**Your Reference: DC/19/111719 Land rear of Ronver Road, Hither Green, Lewisham**

Representations in response to the planning committee report

## Technical Note

**Project: Willow Tree Riding Establishment, Ronver Road, London, SE12  
ONL (DC/19/111719)**

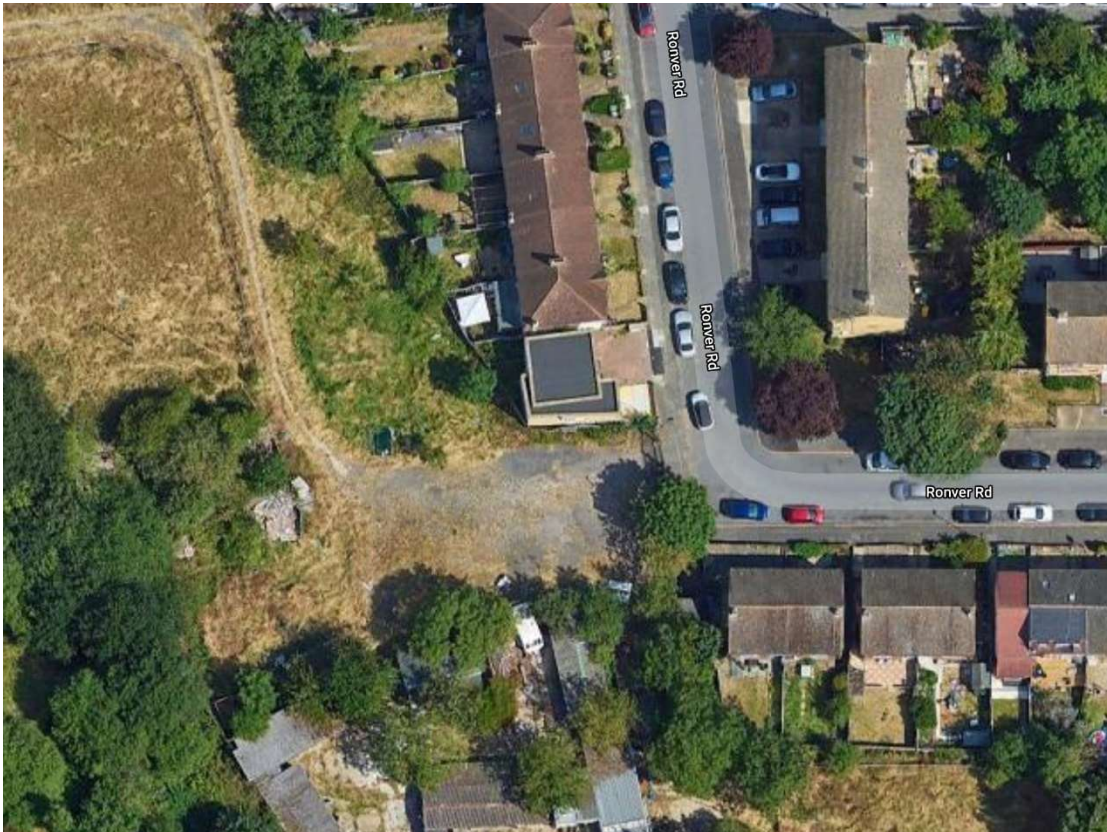
*The only access point to the site is from the existing vehicular access on Ronver Road, which is not wide enough for 2-way vehicle movements. The current application does not propose any changes to the existing access. So users and visitors (pedestrians, cyclists and vehicles) would access the site via the existing access gate.*

The gated shared access is approximately 5.5m, therefore, is wide enough for 2 cars. The arrival and departure numbers are low as assessed in the Transport Statement. A 1-2m footway can, however, be accommodated around the site. Notwithstanding this, the lawful use of the site is already an established riding stables for up to 40 horses. The development proposes to only stable 26 horses resulting in a betterment overall on the site in regards to access and traffic. The local highway authority, therefore, should take account of this fallback position where the existing site can continue to be operated for up to 40 horses.

**Figure 1: Car and Horse Trailer Tracking**

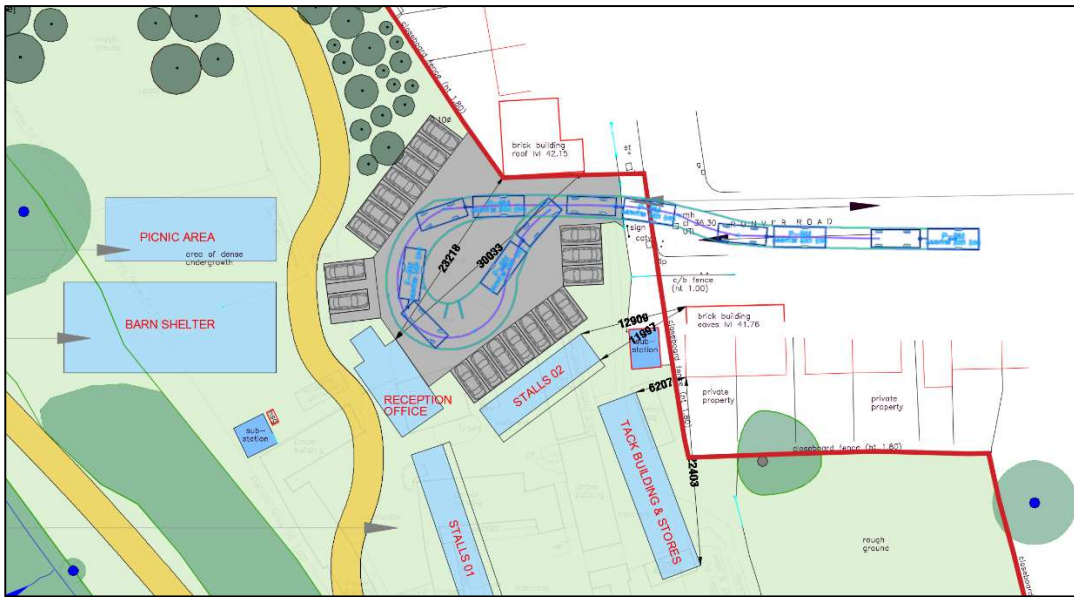
*No swept path analysis is provided to demonstrate that large vehicles can access / egress the site in forward gear within the new sit layout (location of proposed buildings and track adjacent to car park area).*

Tracking of a Car and Horse Trailer is provided in Figure 1 which shows that it can enter and exit in a forward gear whilst Figure 2 shows a 10m Large Truck.
